**RTS-TB-035****18-April-2017****Low frequency Noise / Hum heard on Zeus III audio**

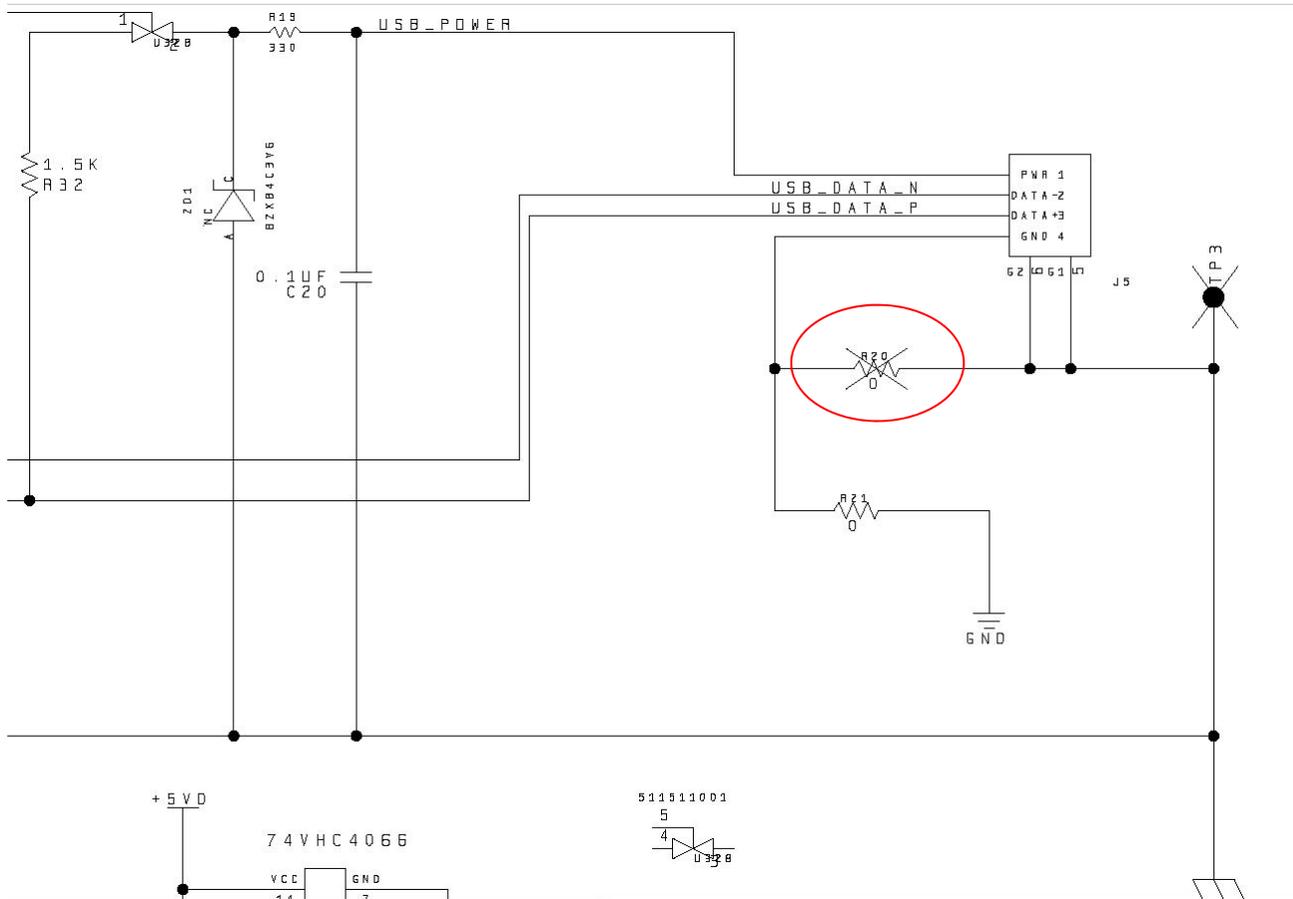
Engineering believes that this issue is caused on certain panels by a high impedance between frame ground and circuit ground internal to the Zeus III design. This creates the environment for ground noise on the audio lines.

The following shows the schematic with R20. The “X” over the resistor symbol indicates the resistor is currently not populated. Note that if populated, R20 would connect circuit ground to frame ground on the Zeus III Main PCBA. Connector J5 is the USB port on the front of the Zeus III.

Bosch recommends a simple rework which we believe will address this issue. The schematics and PCBA layout of the Zeus III Main PCBA contains a resistor R20 which is currently depopulated on shipments. This resistor is a 2010 package geometry. If this resistor is replaced with a 0 Ohm equivalent (or the pads simply shorted together), this should eliminate the noise issue and create the same benefit that connecting an external USB device has.

Close-up view of resistor pads location R20:

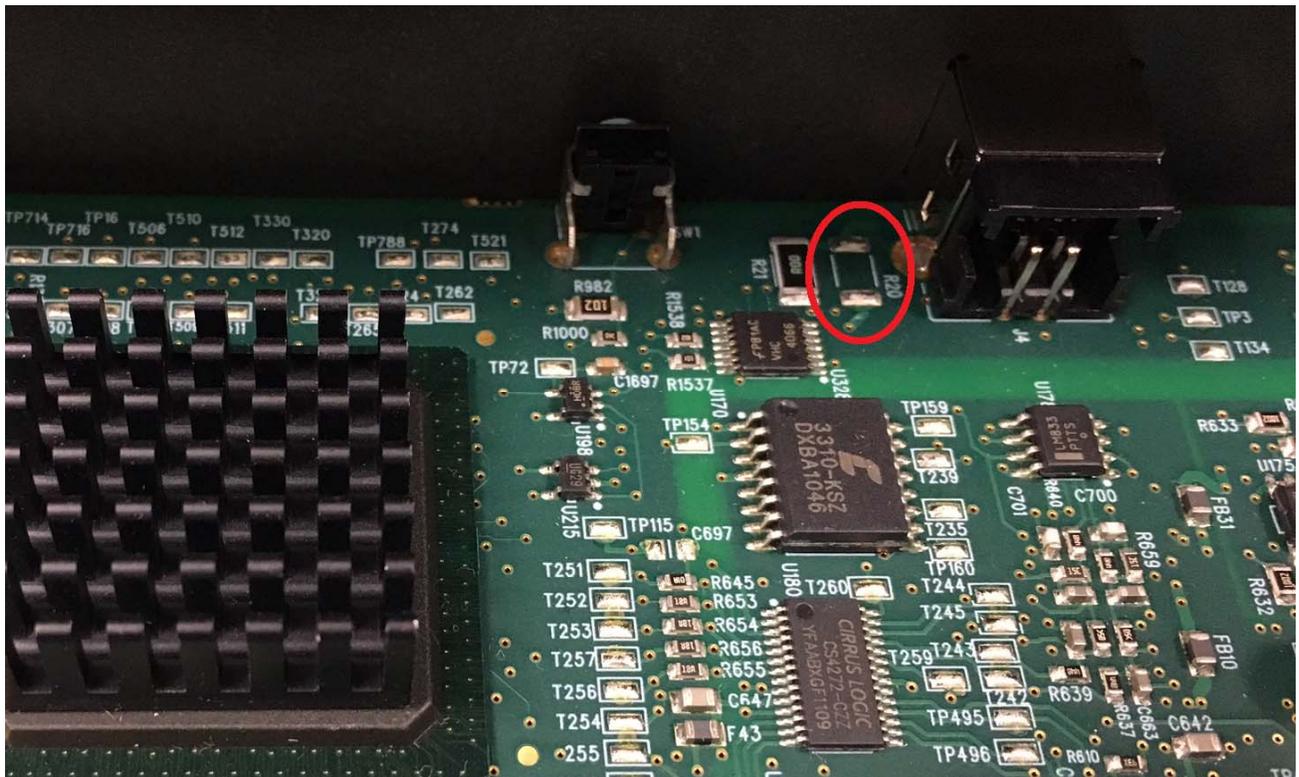
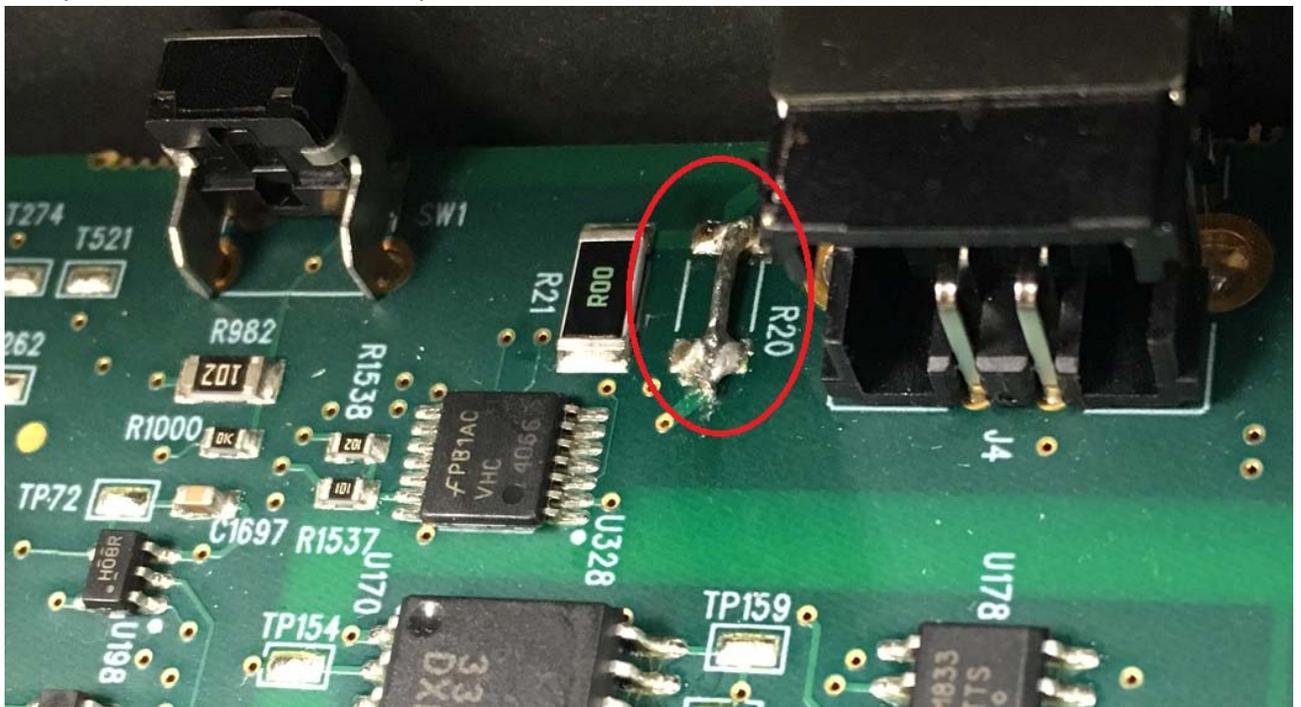
3. Identify resistor pads location R20 on the Main PCBA. Refer to the following pictures that show the resistor pads location R20.

4. Carefully solder an appropriate 0 Ohm 2010 resistor (SAP# F01U161791 or F01U162449) or a piece of wire between both pads of R20.
